Part 20.25A Downtown

20.25A.010 General.

Figure 20.25A.090.A.1.

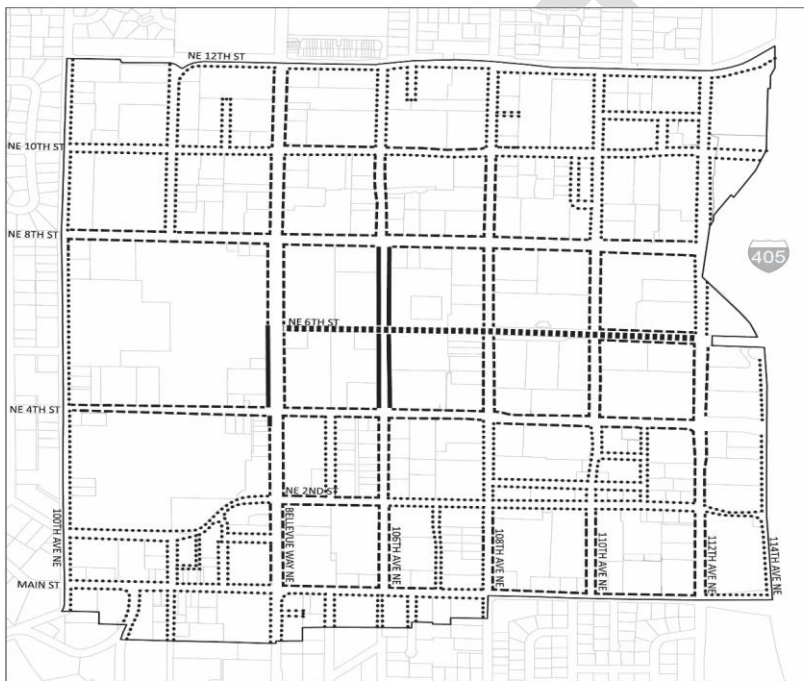
Commented [A11]: The IT Department will update the legend for consistency with the new Grand Connection section.

Figure 20.25A.170.B.

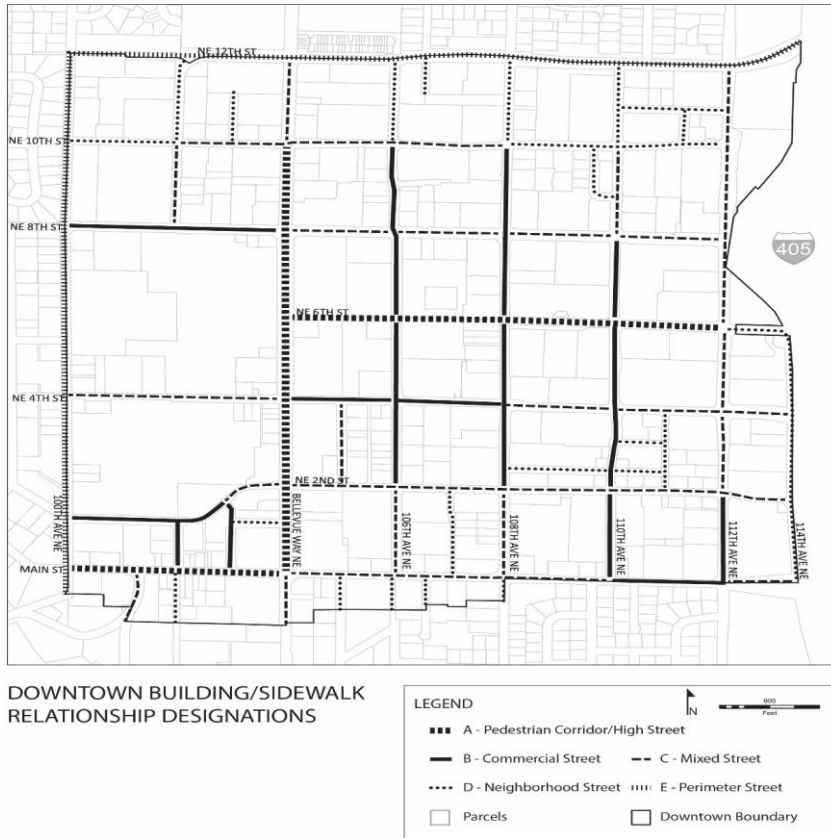
Commented [A14]: IT Department will update legend and change 102nd Avenue NE, between NE 1st Street and Main to "A" ROW to align with the new Grand Connection section.
